PLANNING AND ZONING COMMISSION ACTION ITEM STAFF SUMMARY JUNE 5, 2019 PLANNING AND ZONING COMMISSION MEETING

A RESOLUTION APPROVING A CONDITIONAL USE AND LEVEL III DEVELOPMENT APPLICATION FOR A MULTI-FAMILY DEVELOPMENT AT 14 ENSIGN DRIVE.

The Town has received a Level III Development Permit Application for a Conditional Use multifamily development for two duplexes to be located at 14 Ensign Drive, or more specifically located on Lot 1, Block 5, Corinthian Hill Subdivision. The applicant is James Haass.

Corinthian Townhomes 14 Ensign Dr Dillon, CO 80435

1 SITE PLAN SP-1.1 SCALE - 1"=20'-0"

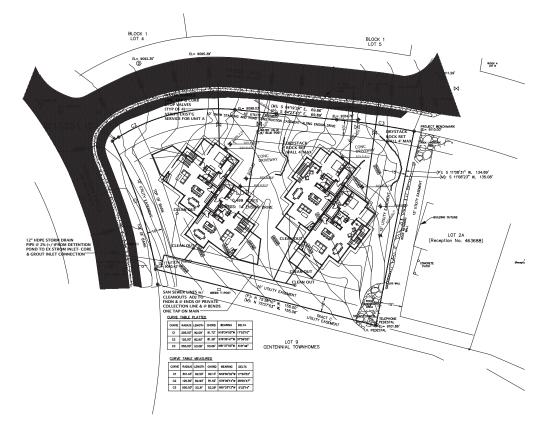
The Application complies with the Code as it relates to Yards. The Application shows a minor roof overhang encroachment into the platted utility easement on the eastern side of Building C-D. A condition of approval is that the Applicant resubmit a site plan where this encroachment is removed. The Town has determined that some underground utilities are present in the utility easement, and the Town is not interested in vacating the easement.

<u>Snow Storage</u>: The site provides ample areas for snow storage adjacent to the proposed driveways. A condition of approval is that a revised site plan be provided, and snow storage areas are required to be shown on the revised site plan. The Application provides enough snow storage area to comply with the Code and will be deemed compliant once the revised site plan is submitted showing snow storage areas of not less than 25% of the hardscape snow removal area.

- B. The Applicant shall submit a revised site plan that removes any portion of a structure, including roof overhangs and deck cantilevers, from the limits of any platted utility easement, prior to issuance of a Building Permit.

- C. The revised site plan shall include the delineation of the required snow storage areas of not less than twenty-five percent (25%) of the hardscape snow removal area.
